Access Compliance Report Public Rights-of-Way (Curb Ramps)

Main Street: SKLAR_ST Cross Street: HYDRANGEA_ST Location: SE

ADA ID: RPRK211103130022 Ramp Type: Type 4 - Parallel Initial Pass/Fail: Fail Overall Compliance: No Severity Score: 16

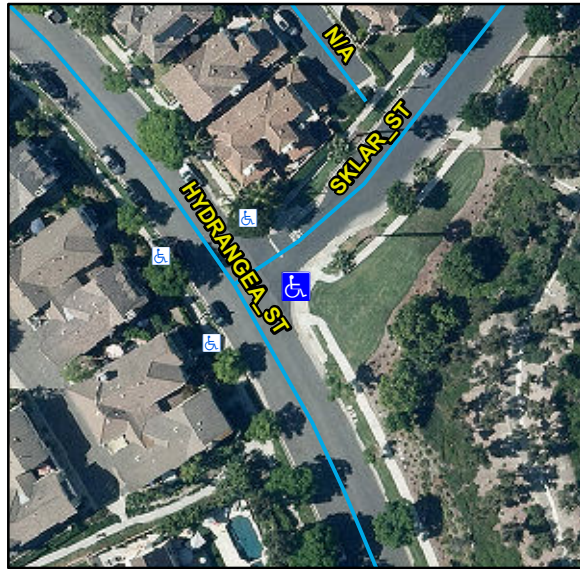
Compliance	Description	Data	Compliance	Description	Data
N/A	Ramp Length LT (in)	135	N/A	Ramp Length RT (in)	137
Yes	Ramp Width LT (in)	84	Yes	Ramp Width RT (in)	84
Yes	Ramp Run Slope LT (%)	3.2	No	Ramp Run Slope RT (%)	9
No	Ramp Cross Slope LT (%)	4.6	Yes	Ramp Cross Slope RT (%)	2
N/A	Landing Present	N/A	N/A	DWS Provided	N/A
N/A	Landing Length (in)	N/A	N/A	DWS Contrast	N/A
N/A	Landing Width (in)	N/A	N/A	DWS Length (in)	N/A
N/A	Landing Run Slope (%)	N/A	N/A	DWS Full Width	N/A
N/A	Landing Cross Slope (%)	N/A		DWS Offset Type	N/A
N/A	Landing Movement Obstructed?	N/A	N/A	DWS Offset Left (in)	N/A
	Landing Movement Type	N/A	N/A	DWS Offset Right (in)	N/A
N/A	Landing Shared	N/A			
N/A	Clear Space	Yes			
N/A	Clear Space To Crosswalk (in)	N/A			
N/A	Marked Crosswalk 1	No	N/A	Marked Crosswalk 2	No
	Crossing 1 Direction	N		Crossing 2 Direction	W
	Marked Crosswalk 1 Width (in)	N/A		Marked Crosswalk 2 Width (in)	N/A
N/A	Ramp Inside Crosswalk 1	N/A	N/A	Ramp Inside Crosswalk 2	N/A

Crossing 1 Slope (%)	1.1		Crossing 2 Slope (%)	1.6
	Crossing 1 Cross Slope (%)	1.8		Crossing 2 Cross Slope (%)	3.5
N/A	Gutter Ponding	N/A	N/A	Curb Slope	11
Yes	Gutter Lip Height (in)	0		Road Run Slope (%)	2.2
N/A	Gutter Run Slope (%)	N/A		Road Cross Slope (%)	2.7
N/A	Gutter Cross Slope (%)	N/A	No	Perpendicular Joint Present	No
Yes	Overall Surface Condition	Acceptable			
	Cross Gutter Present?	No		Spandrel Present?	No
	Replace Cross Gutter?	N/A		Replace Spandrel?	N/A

Remove & Replace Curb Ramp With Two New Directional Ramps or Equivalent.

R204.3, R304.5.3, R304.3.2, STD 1115
